PROPOSED CHANGES TO APPENDIX A
TECHNICAL SPECIFICATIONS
FOR
FACILITY OPERATING LICENSES NPF-37, NPF-66, NPF-72, and NPF-77

AFFECTED PAGE INDEX

BYRON

BRAIDWOOD
AFFECTED PAGES

FIGURE 2.1-1

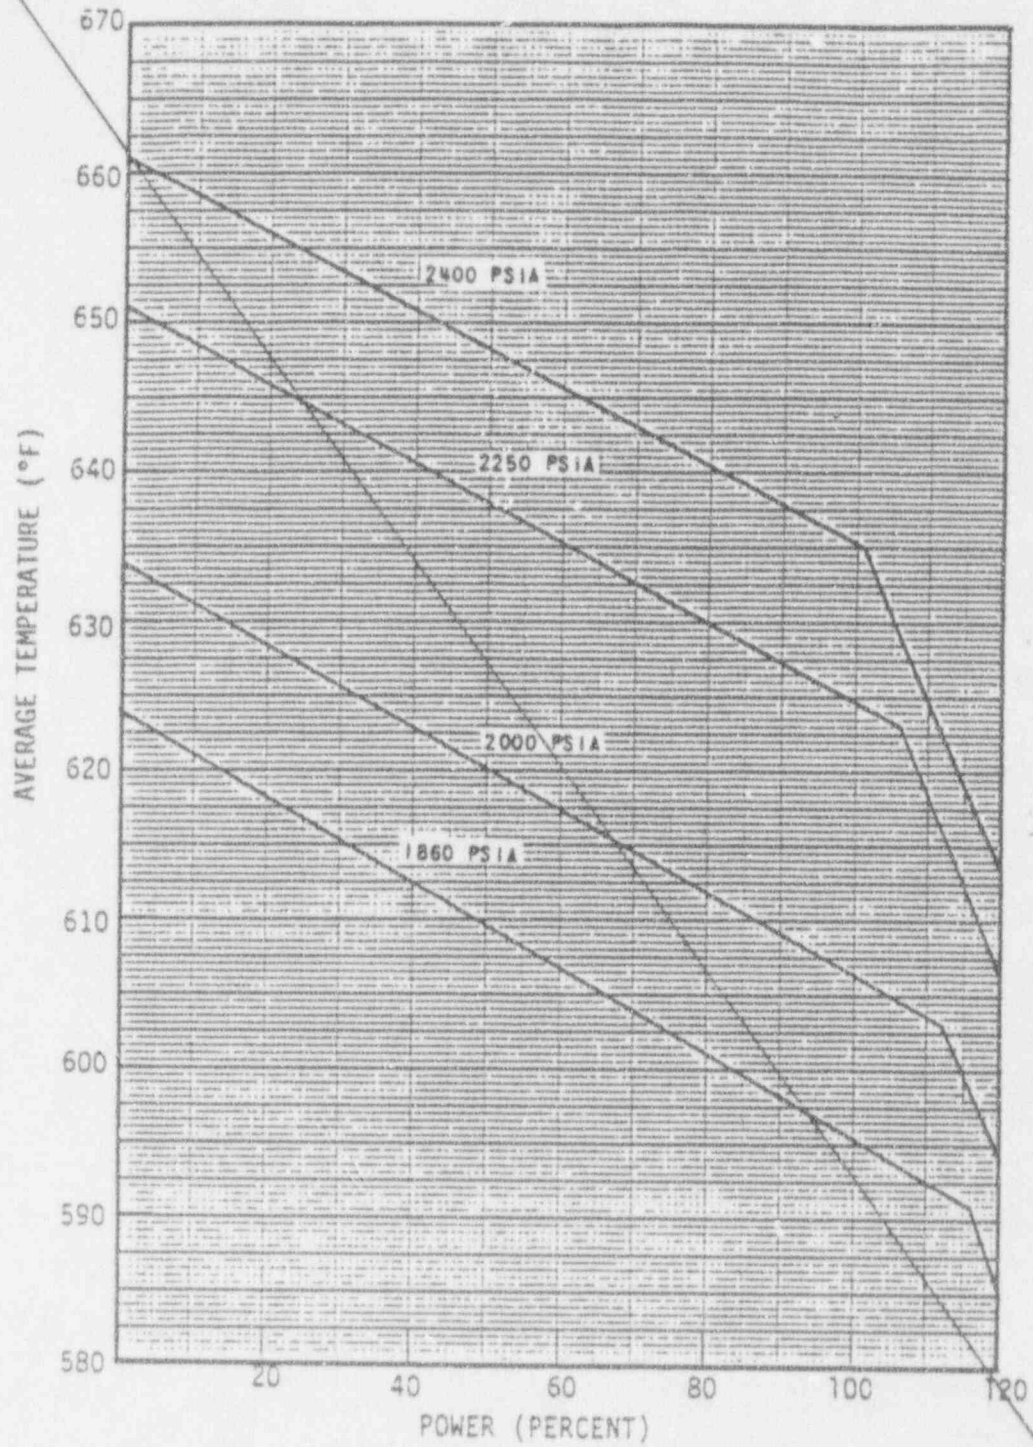
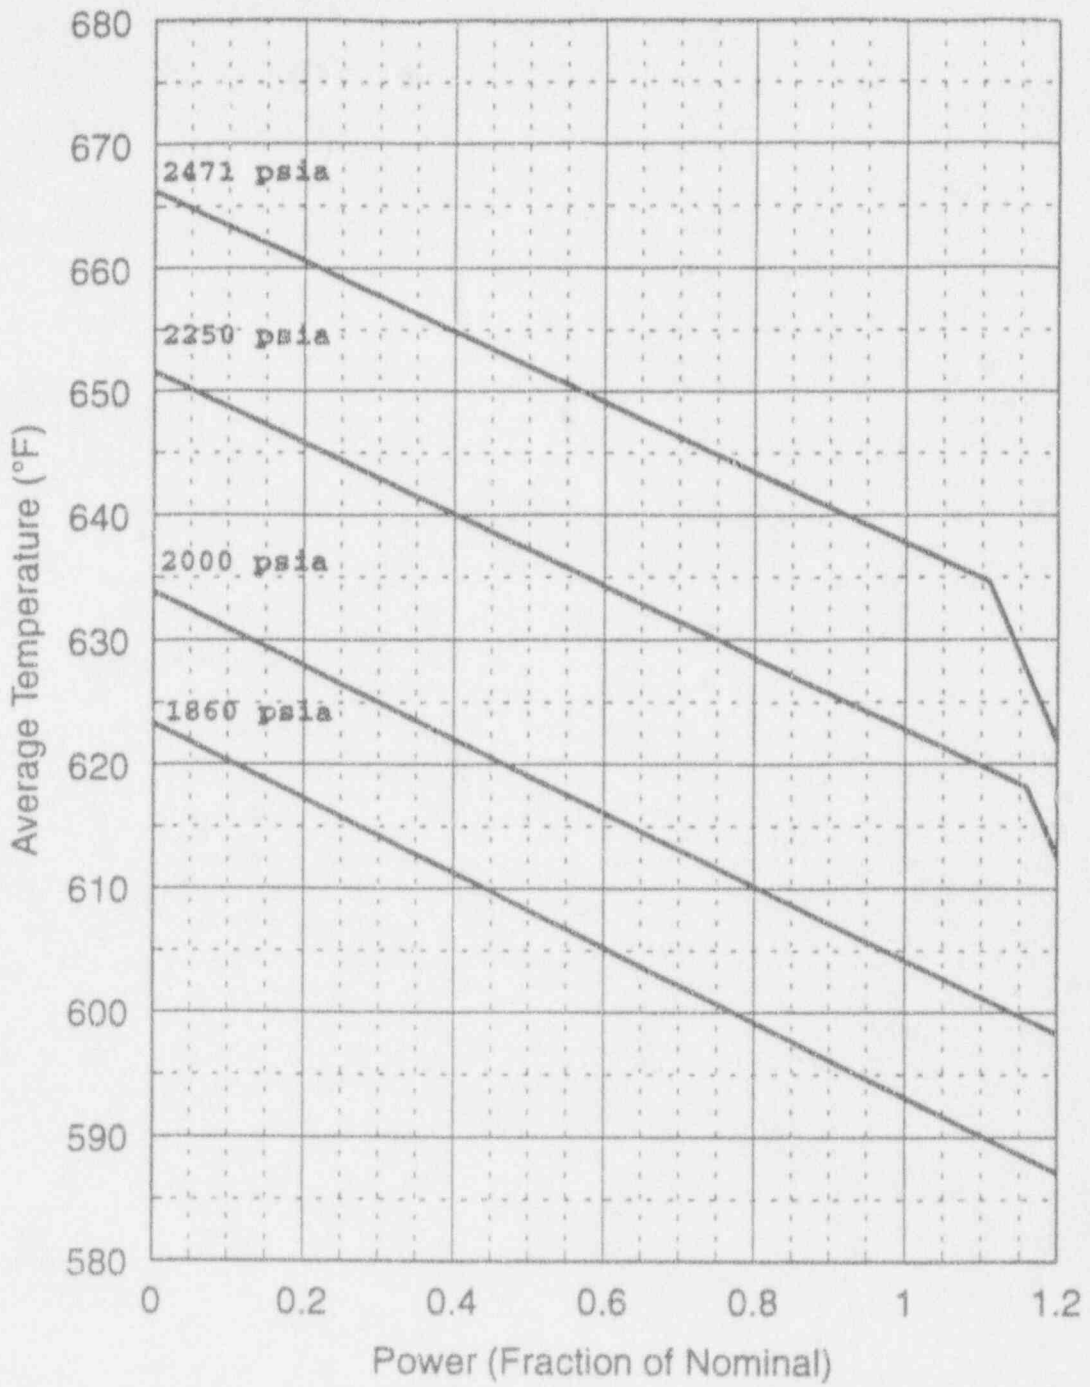
Replace Figure 2.1-1 with Figure 2.1-1 on the next page

The curves of Figure 2.1-1 show the loci of points of THERMAL POWER, Reactor Coolant System pressure and average temperature for which the minimum design DNBR is no less than the design DNBR value, or the average enthalpy at the vessel exit is less than the enthalpy of saturated liquid.

Figure 3.1-0 **
 Moderator Temperature Coefficient vs. Power Level

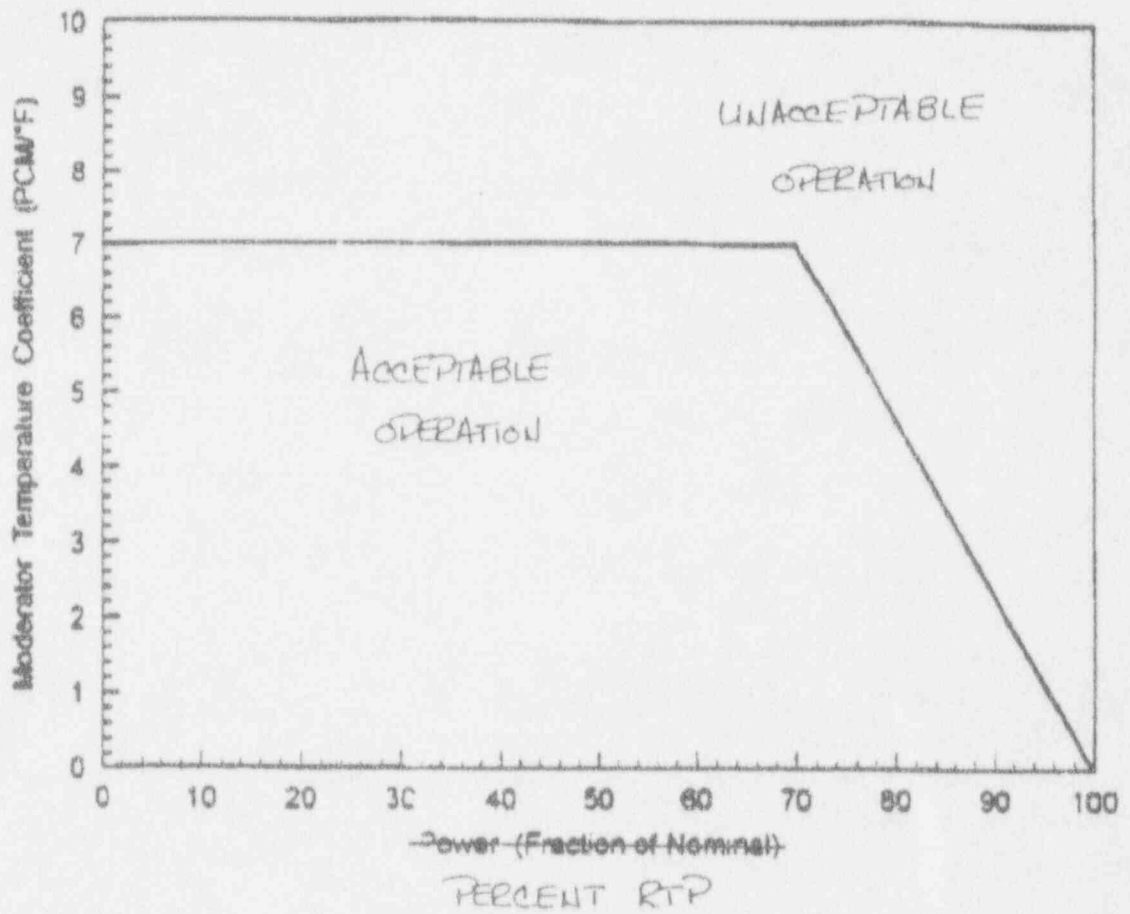
a.1 ^{**} Maintained within the limits specified in Figure 3.1-0, ^{Figure 3.1-0} ^{**}

$+7.0 \times 10^{-5} \Delta k/k/^\circ F$ for all rods withdrawn for power levels up to 70% RATED THERMAL POWER with a linear ramp to $0 \Delta k/k/^\circ F$ at 100% RATED THERMAL POWER

FIGURE 2.1-1

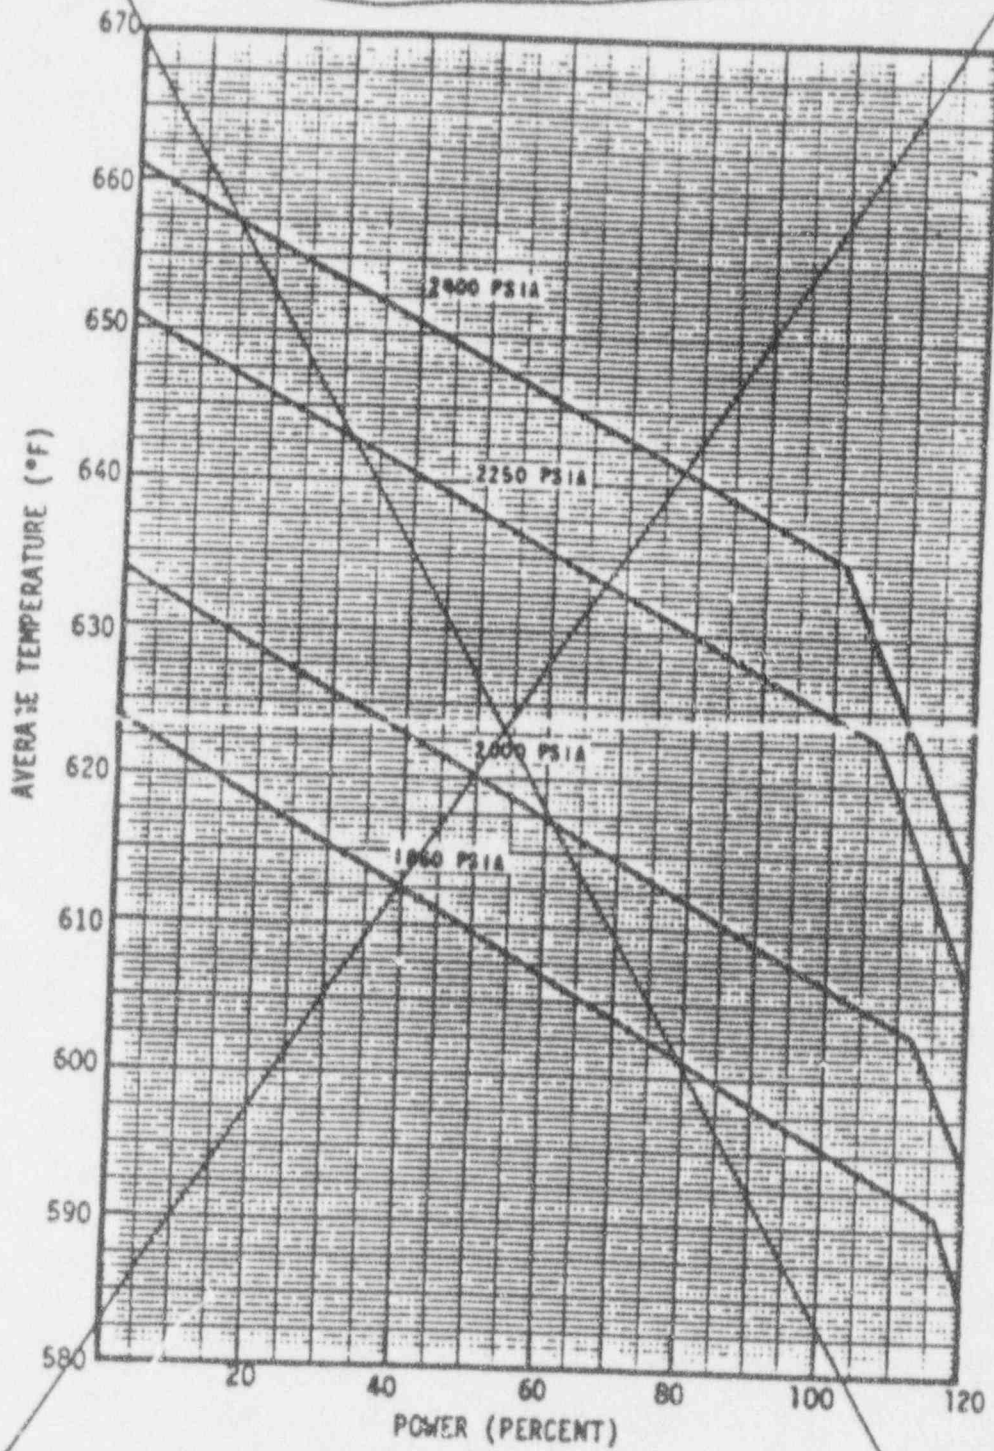
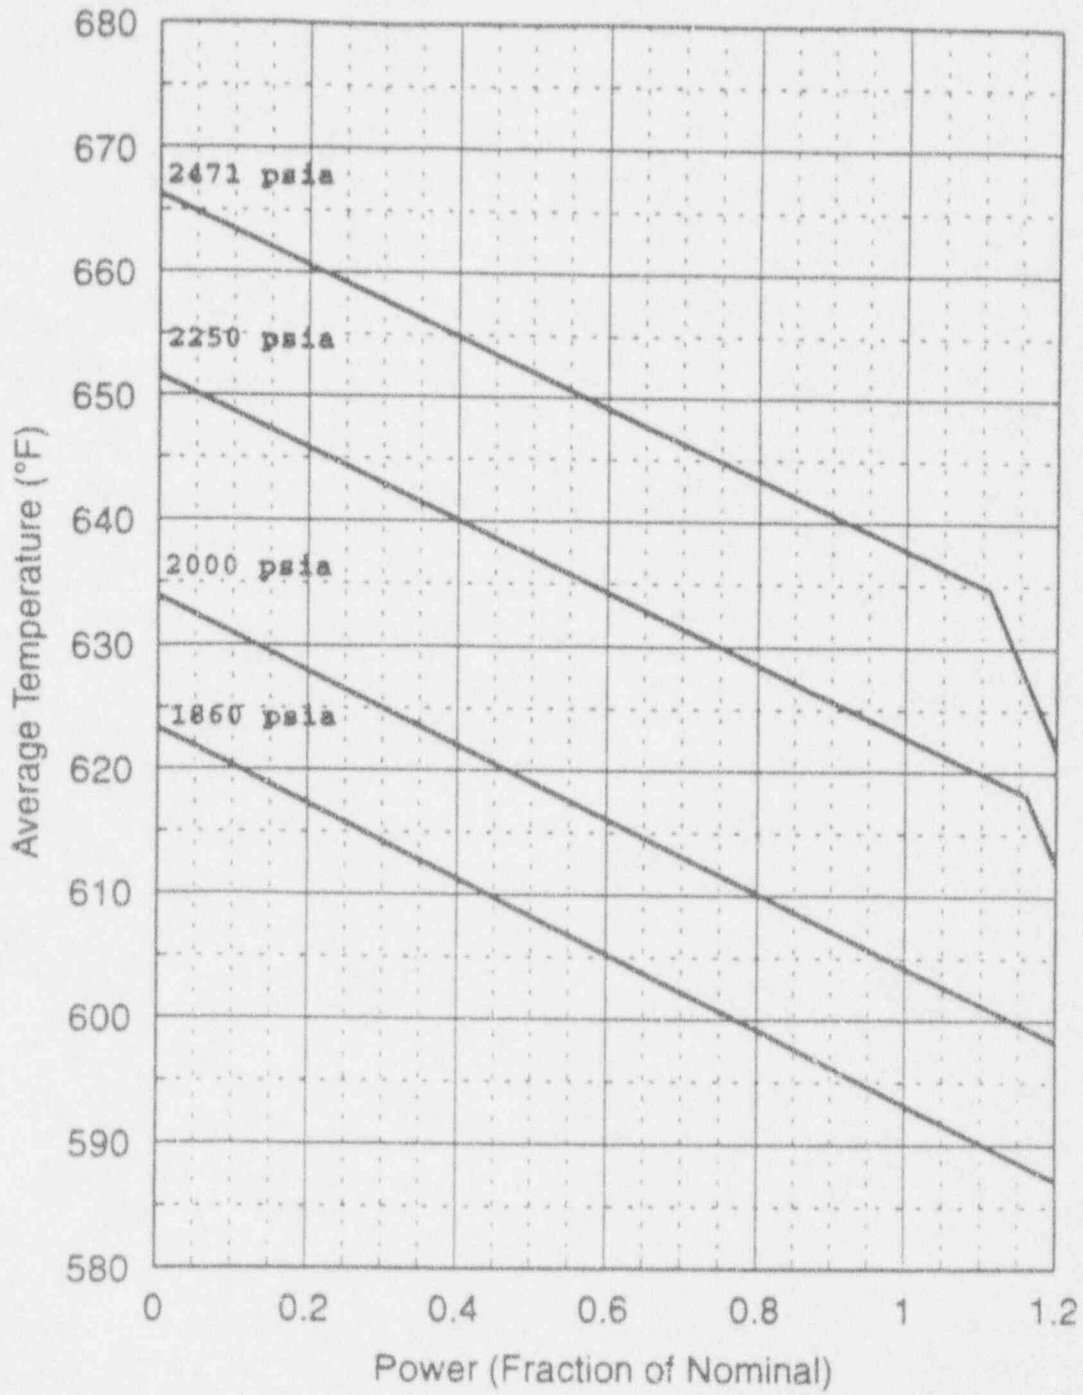
Replace Figure 2.1-1 with Figure 2.1 on next page

The curves of Figure 2.1-1 show the loci of points of THERMAL POWER, Reactor Coolant System pressure and average temperature for which the minimum design DNBR is no less than the design DNBR value, or the average enthalpy at the vessel exit is less than the enthalpy of saturated liquid.

FIGURE 3.1-0**

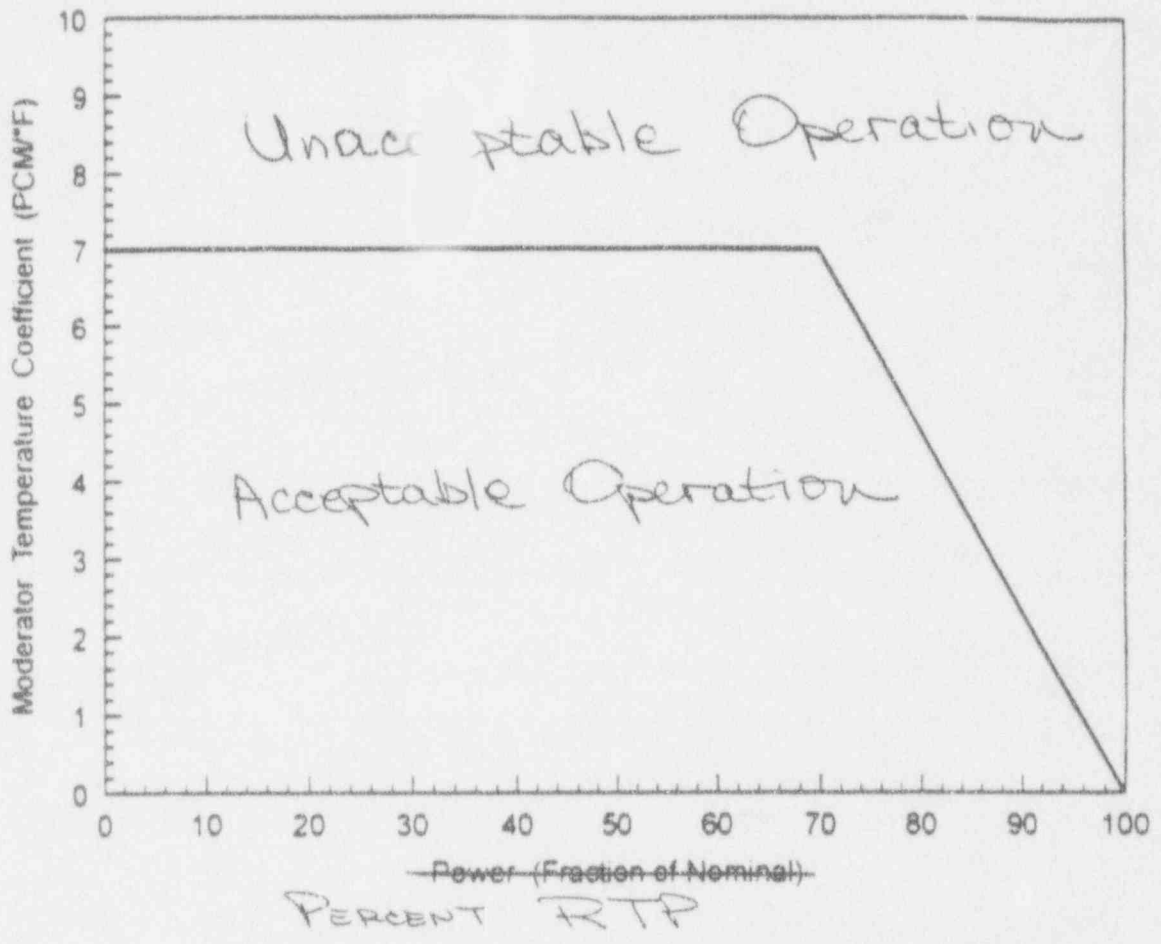
a.2.** Maintained within the limits specified in FIGURE 3.1-0, and

The MTC change would allow a slightly positive MTC (PMTC) below 100 percent of rated full power. The principal benefit of this change is that it would facilitate the design of future reload fuel cycles. Technical Specification changes are also required to meet SDM requirements to accommodate the positive MTC and the potential of lengthened reload fuel cycles due to increased energy requirements. To assure subcriticality requirements are met following a postulated loss-of-coolant accident (LOCA), the boron concentration is increased for the refueling water storage tank (RWST) and the accumulators. The safety analyses for the Byron and Braidwood Updated Final Safety Analysis Report (UFSAR) transients have been previously based on a maximum MTC being less than or equal to 0 pcm/°F at all times when the reactor is critical. The proposed change to the Technical Specification would allow a +7 pcm/°F MTC for power levels up to 70 percent with a linear ramp to 0 pcm/°F at 100 percent power. CECo has reviewed the revised USFAR safety analyses which conservatively bounds this positive MTC, increase in boron concentration, incorporates revised thermal design flows, and addresses increased tube plugging levels. The results of the revised analyses are provided in WCAP 13964 "Commonwealth Edison Company Byron and Braidwood Units 1 and 2 Increased SGTP/Reduced TDF/PMTC Analysis Program Engineering/Licensing Report".
